RE: Addendum #1 24-50 Redwood Avenue Drainage Improvement CDBG-DR Project M0015

Please accept this as Addendum No. 1 for the above referenced solicitation.

BAY COUNTY PUBLIC WORKS DEPARTMENT ENGINEERING DIVISION CONTRACT PLANS DEO AGREEMENT NO.M0015 (FEDERAL FUNDS) REDWOOD AVENUE DRAINAGE IMPROVEMENTS PROJECT BAY COUNTY, FL

SHEET NO.
G-102

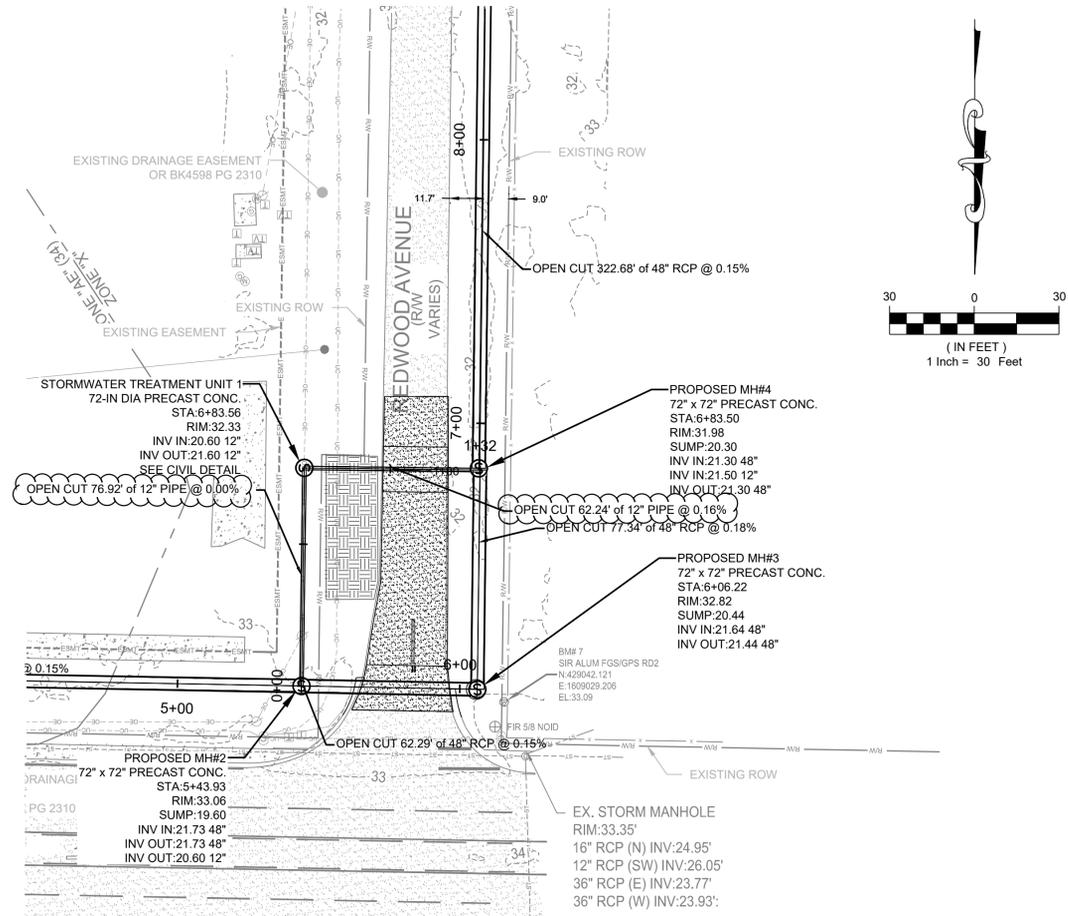
For clarification purposes, new information regarding the expected dewatering effort for the outfall structure has been depicted on Sheet C-402 and Bid Pay Item Note SPI-3 on Sheet G-102 of the revised construction plans.

PROJECT NO. M2315298.00	SHEET NO. C-107
DATE NOVEMBER 2023	
SCALE AS NOTED

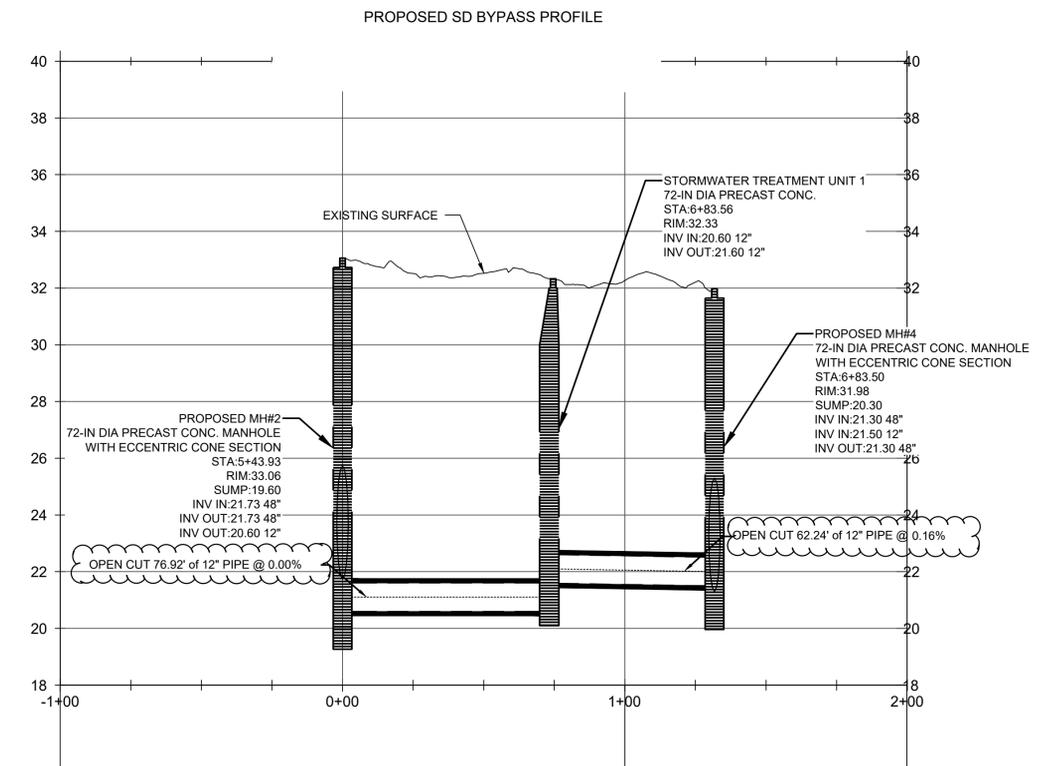
8. Is it the contractor's responsibility to coordinate with FPL on the power pole relocations, if so, can you provide an FPL contact? **The County has initiated the coordination efforts for the FPL power pole relocations. The poles are anticipated to be moved prior to the start of construction.**
9. On Pg C-107 the plan view calls out the 12" to be SDR 21, on the profile it is called out as 12" RCP. Can you please clarify? **Please see the attached revised construction plans and Addendum 1 Revised Bid Form.**
